Access Compliance Report

Public Rights-of-Way

Intersection ID: 19402	Main Street: GRETNA_GREEN_DR	Cross Street: S_TRYON_ST	Location: NE
ADA ID: 223D0DAC9553	Ramp Type: Perp	Initial Pass/Fail: Fail	Overall Compliance: No
Severity Score: 22.5			
Codes/Mitigation Info/Possible Solution		Field Measurements/Component Compliance

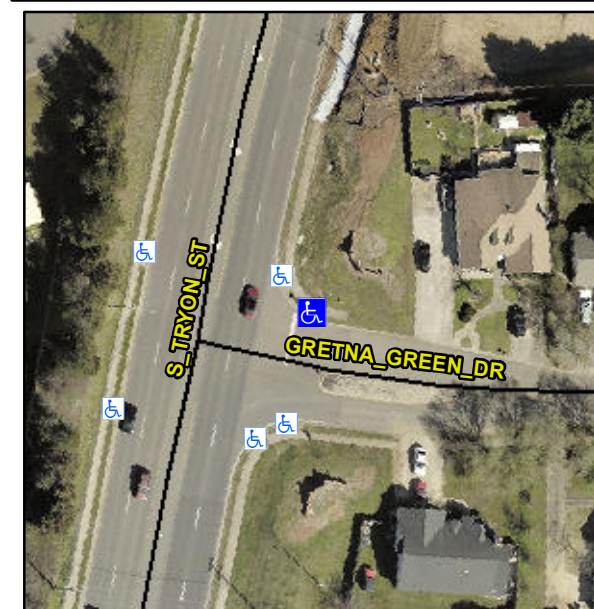
Not Found, R304.5.1, R304.2.2, R304.5.3

Compliance	Description	Data	Compliance	Description	Data
N/A	Ramp Length (in)	91.0	No	Ramp Slope (%)	9.6
No	Ramp Width (in)	45.0	No	Ramp XSlope (%)	2.4
N/A	Flare Type LT	N/A	N/A	Flare Type RT	N/A
N/A	Flare Slope LT (%)	N/A	N/A	Flare Slope RT (%)	N/A
N/A	Flare Traversable LT?	N/A	N/A	Flare Traversable RT?	N/A
N/A	Landing Length (in)	N/A	N/A	DWS Provided?	N/A
N/A	Landing Width (in)	N/A	N/A	DWS Contrast?	N/A
N/A	Landing Slope (%)	N/A	N/A	DWS Length (in)	N/A
N/A	Landing X Slope (%)	N/A	N/A	DWS Full Width?	N/A
N/A	Landing Curb? (Y/N)	N/A	N/A	DWS Offset (in)	N/A
N/A	Shared Landing?	N/A			
N/A	Gutter Ponding?	N/A	N/A	Gutter Slope (%)	N/A
N/A	Gutter Lip Ht (in)	N/A	N/A	Gutter X Slope (%)	N/A
N/A	Painted X Walk1?	No	N/A	Painted X Walk2?	N/A
	X Walk 1 Direction	To S		X Walk 2 Direction	N/A
N/A	X Walk 1 Width (in)	N/A	N/A	X Walk 2 Width (in)	N/A
	X Walk 1 Slope (%)	1.5		X Walk 2 Slope (%)	N/A
	X Walk 1 X Slope (%)	3.9		X Walk 2 X Slope (%)	N/A

Remove & Replace Entire Ramp.
